AIRWORTHINESS DIRECTIVE

TYPE AFFECTED: Club Astir III, Club Astir IIIb and Standard Astir III.

SUBJECT: Inspection and replacement of the rudder pedal slide unit.

Technical Information TM 306-22	GROB G 102 CLUB ASTIR III and IIb STANDARD ASTIR III	
Subject:	Inspection and exchange of the slide at the pedal unit.		
Effectivity:	Under GROB G 102 from serial no. 5501 CLUB ASTIR III until serial no. 5569-C, CLUB ASTIR IIb until serial no. 5568-Cb and STANDARD ASTIR III until serial no. 5564-S included.		
Accomplishment:	Instruction 1 before next start. Instruction 2 until realization of instruction 3. Instruction 3 not later than June 15, 1983.		
Reason:	At the pedal unit of the mentioned serial numbers, slides were partially mounted which might break when overloaded.		
Instructions:	<u>Instruction 1:</u> Inspection of the slide at the pedal unit before next start. If the slide no. 103B-4208.10 (picture 1) with the wide, high cross-web is installed, there is no reason for reclamation. Instructions 1 and 2 are not applicable. If the slide no. 103-4208.10 (picture 2) with the small low cross-web is installed, instructions 2 and 3 have to be carried out. <u>Instruction 2:</u> Until rea

Slide no. 103B - 4208.10

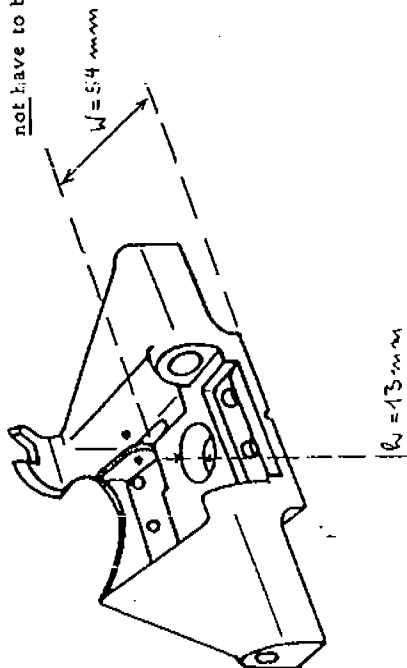
This slide with wide, high cross-web is safe and does not have to be exchanged.

Slide no. 103 - 4208.10

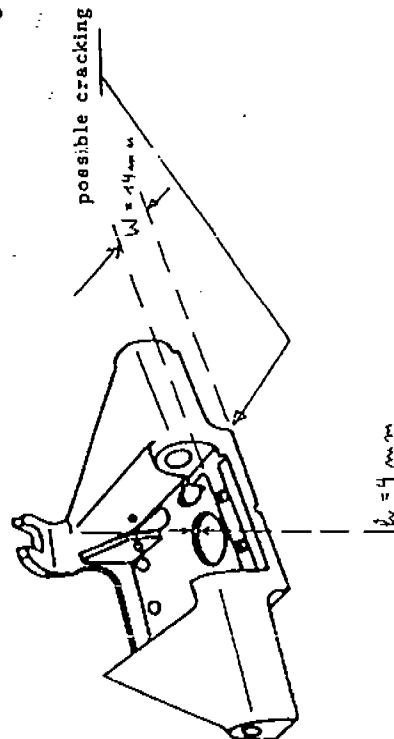
This slide with small, low cross-web is rejected and has to be exchanged.
